## Attachment II

### JUSTIFICATION AND SAFETY ANALYSIS

The proposed changes to the McGuire Nuclear Station Technical Specifications seek to clarify and revise the requirements for maintaining and testing the D. C. Power sources at McGuire (Technical Specifications 3/4.8.2 and 3/4.8.3). A number of items in these technical specifications have been determined to be inconsistent or incorrect and require correction.

Figure 1

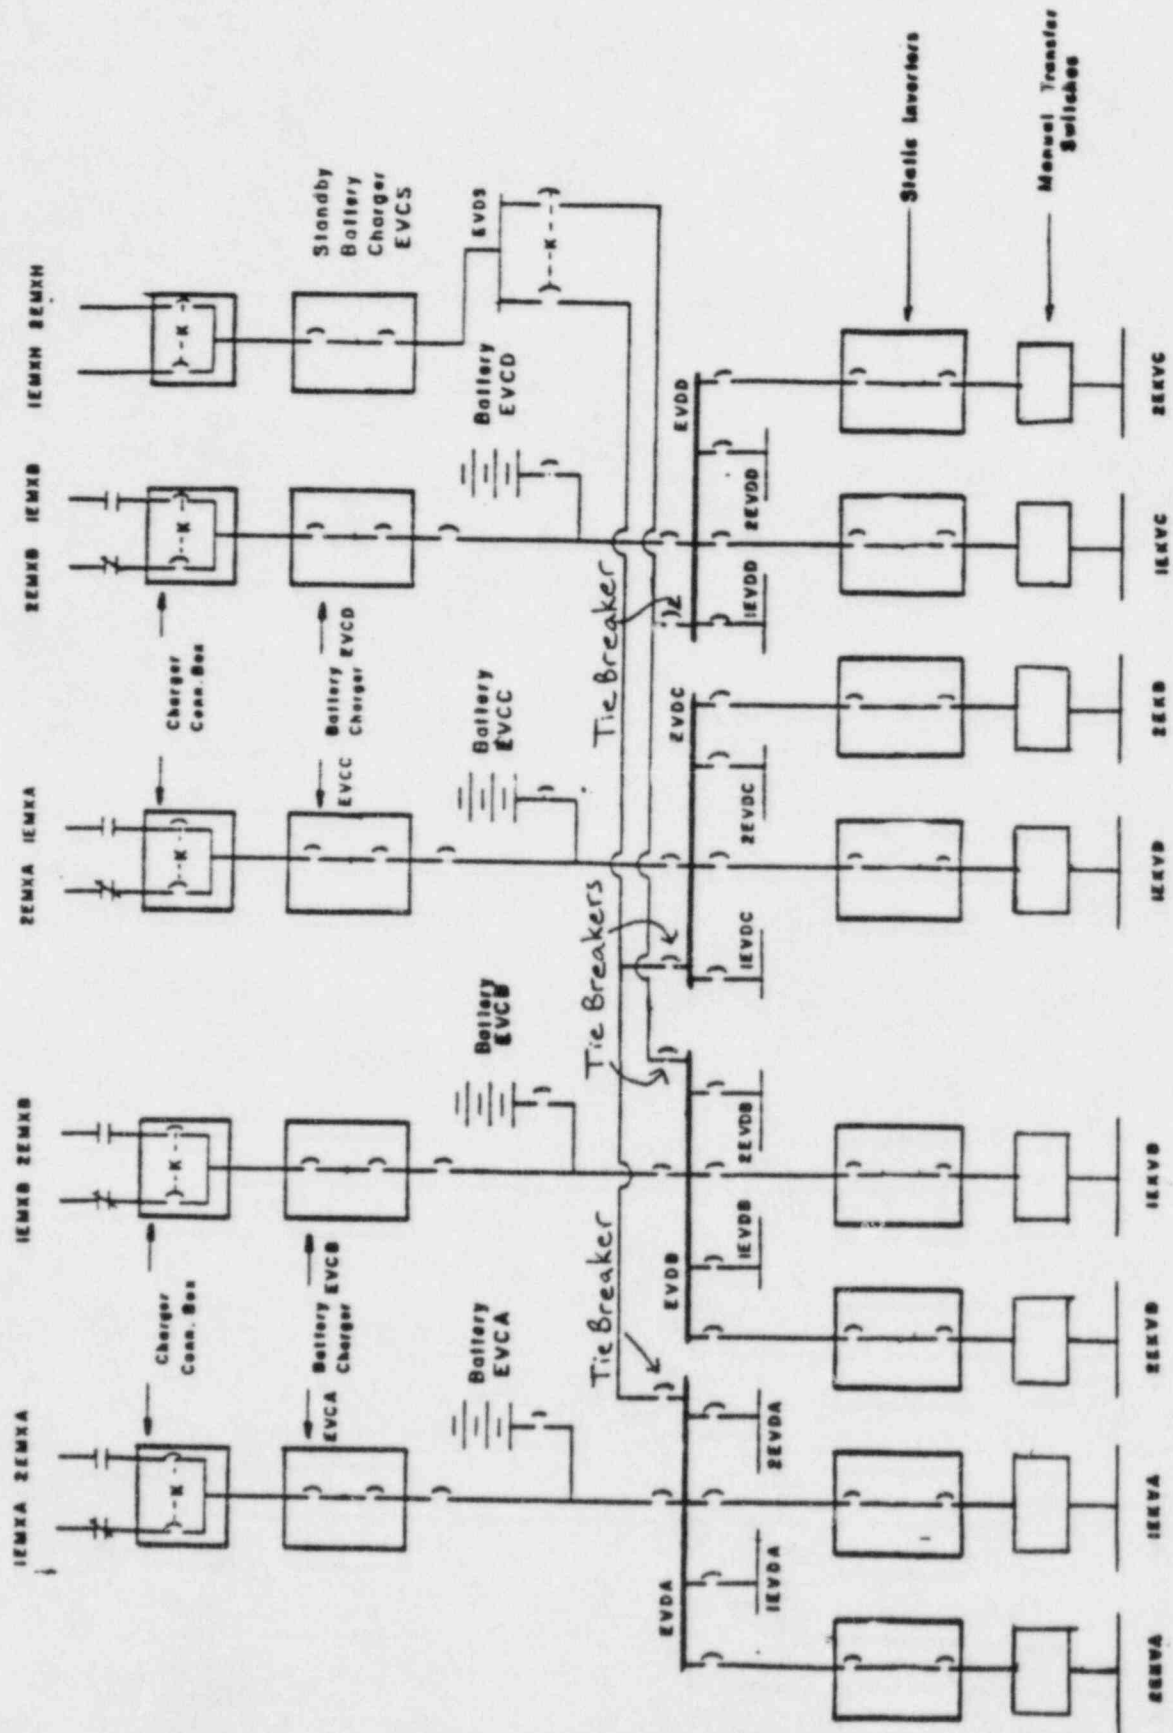
standard technical specifications were written for a two battery system with each battery carrying two channels. McGuire's technical specifications do not take credit for the four battery system with each battery carrying a single channel as shown in Figure 1. With the four battery system at McGuire, each battery is sized to handle the loads of two channels in a blackout in conjunction with a safety injection situation. In a single failure situation with two channels tied, two channels will still be operable with the four battery system, therefore, no safety margins will be decreased by increasing the allowable outage time to seven days.
